REQUEST FOR INFORMATION	DATE: March 29, 2017	NO.: RFI-501
--------------------------------	-----------------------------	---------------------

Project Name: 15051-Webster University Interdisciplinary Science Building

Subject: Vacuum Pump Exhaust Vent and Natural Gas Venting Locations

2 SECTION THROUGH NORTH WING LOOKING SOUTH BUILDING SECTIONS
1/16" = 1'-0"

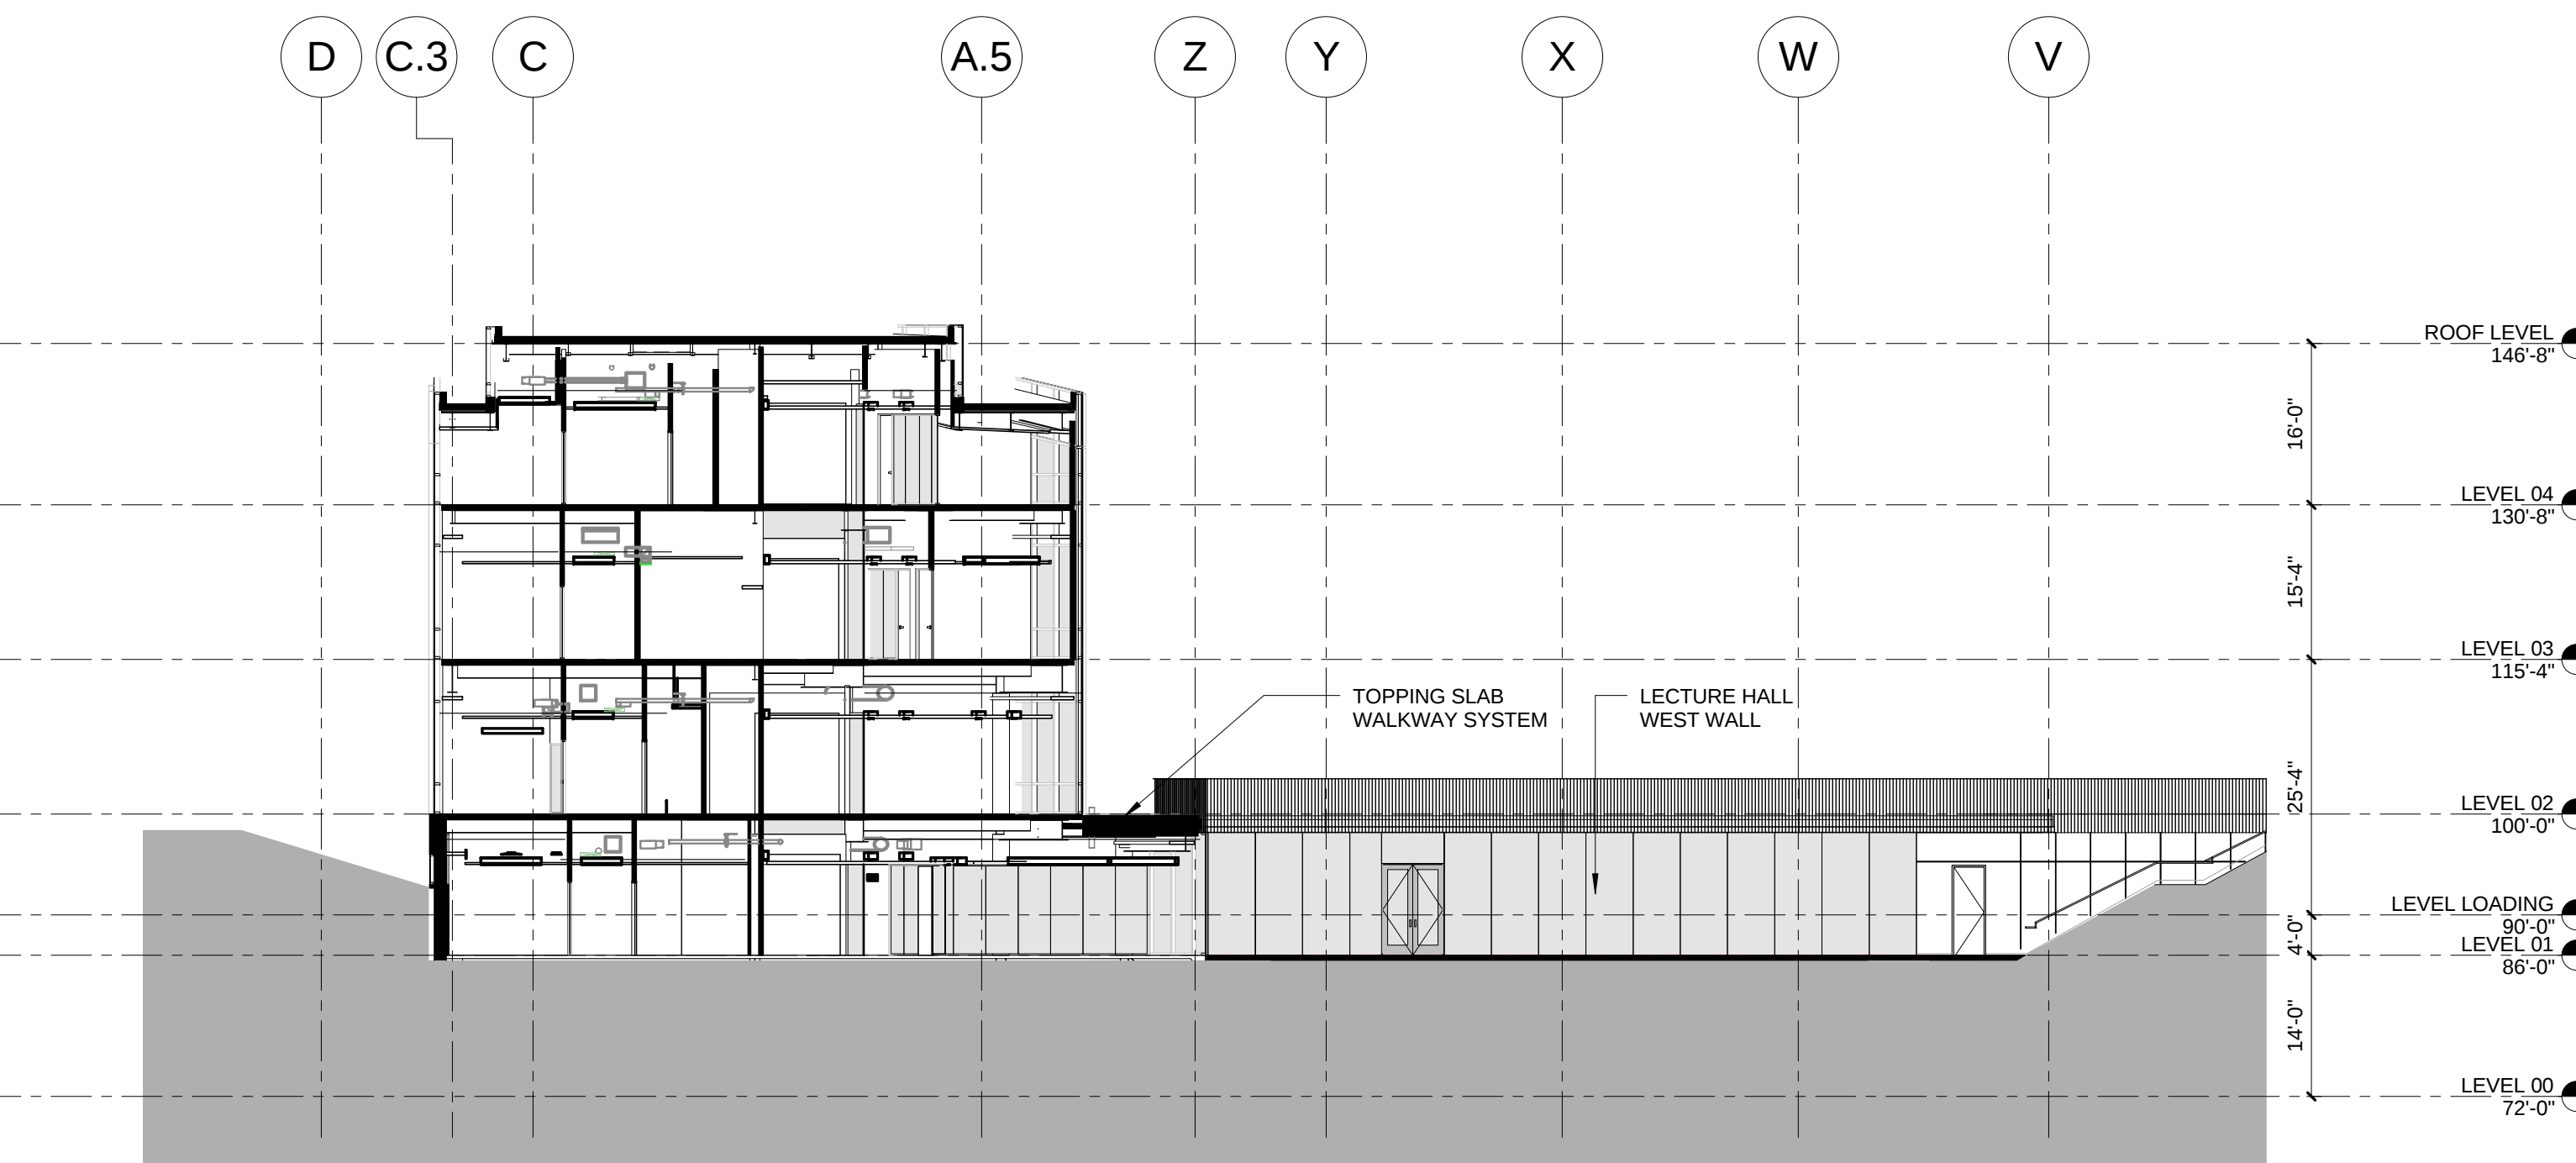
Proposed natural gas and vacuum pump exhaust vent locations are attached. Locations chosen to follow applicable code (below) and to be concealed as much as possible. Vents will be between 6' and 10' above intake louver. All three vents will turn down to prevent water/debris infiltration.

Contractor proposed vent pipe discharge locations appear to be acceptable to WTA and meet the intent of the Code. Contractor to properly install any dissimilar metals to avoid galvanic corrosion. Architect has requested vent pipes to be painted to match the exterior of the building. Coordinate color and final location with Architect.
